DART AEROSPACE LTD	Work Order:	94880
Description: Crosstube Assembly (205/212/412 Low Fwd)	Part Number:	D212-664-147
Inspection Dwg: D212-664-147 Rev: B		Page 1 of 2

DRAWING NO. D212-664-147	TITLE CROSSTUBE ASS'Y (205 LOW FWD)	REV. B	DART AEROSPACE LTD ENGINEERING ORDER		D.E.O. NO. D212-664-147-B-1	SHEET NO. SHEET 1 OF 1	SCALE NTS
DRAWN 92	CHECKED ASS	MFG. APPR. 183	APPROVED JMP		DE APPR. H		
DATE 11.07.15	DATE 11.07.20	DATE 11.07.21	DATE 11/07/21		DATE 11.07.21

PURPOSE:

REPLACE MAGNOBOND WITH PROSEAL.

**D212-664-147/-147B
ASSEMBLY DETAIL**

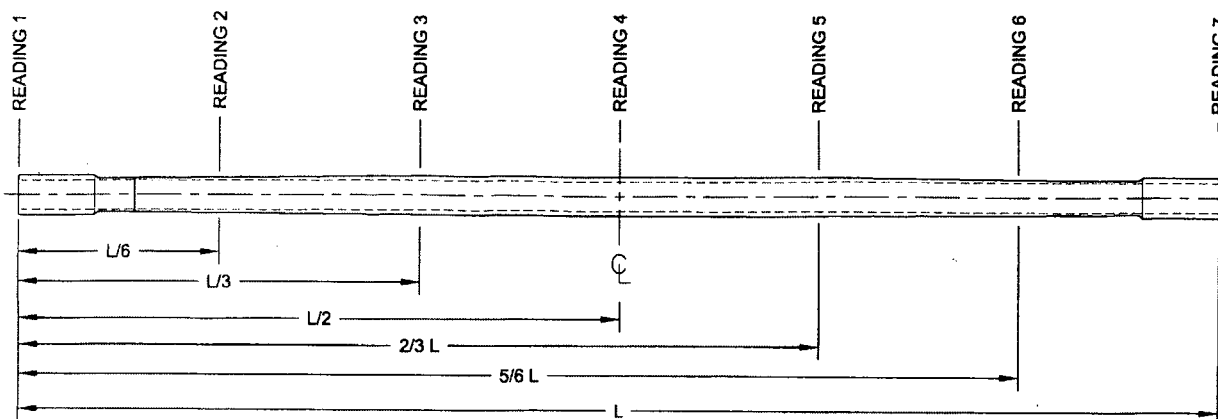
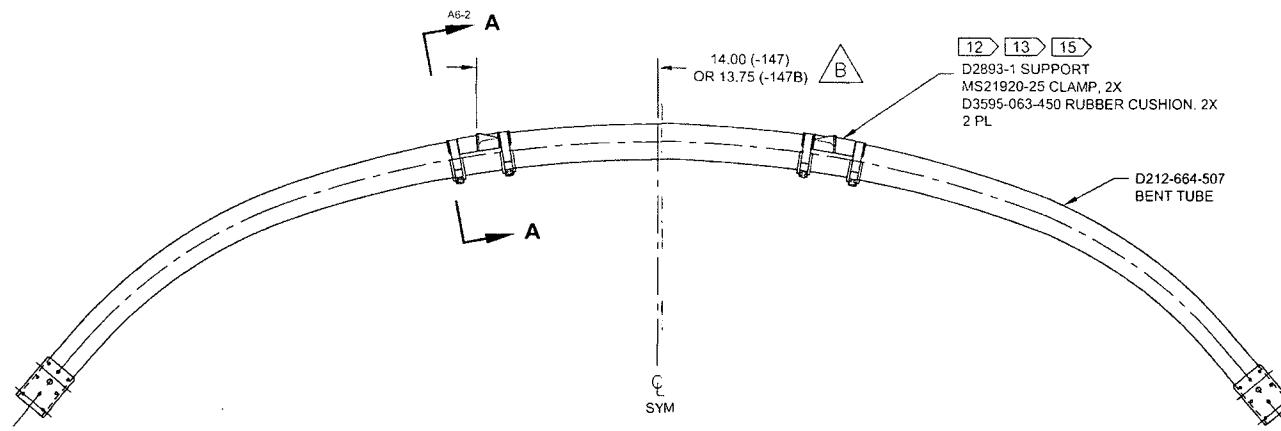
NOTE 12 & 15, SHEET 1 IS AMENDED AS FOLLOWS:

WAS:

- 12) INSTALL D2893-1 SUPPORT USING 0.03" TO 0.06" THICK LAYER OF MAGNOBOND 6398 TO THE SURFACE OF D2893-1 THAT WILL BE IN CONTACT WITH THE CROSSTUBE PER QSI 015. LET CURE FOR 12 HOURS AFTER INSTALLATION AND PRIOR TO PACKAGING.
- 15) TORQUE CLAMPS 80 TO 100 IN-LB. ENSURE AT LEAST 1.5 THREADS SHOWING IN SAFETY AND THAT NUT HAS NOT BOTTOMED-OUT AFTER TORQUING.

IS:

- 12) TO INSTALL D2893-1 SUPPORT: ABRASE MATING SURFACE OF SUPPORT AND CROSSTUBE WITH 180-GRIT SANDPAPER AND REMOVE RESIDUE WITH MEK (OR EQUIVALENT). APPLY A 0.04" TO 0.07" THICK LAYER OF PROSEAL 890 CLASS B-2 (OR AMS-S-8802 CLASS B-2) SEALANT TO MATING SURFACE OF SUPPORT.
- 15) TORQUE CLAMPS 80 TO 100 IN-LB. ENSURE AT LEAST 1.5 THREADS SHOWING IN SAFETY AND THAT NUT HAS NOT BOTTOMED-OUT AFTER TORQUING. **PRIOR TO PACKAGING, RE-CHECK TORQUE ON CLAMPS AFTER PROSEAL 890 SEALANT HAS CURED FOR 72 HOURS.**
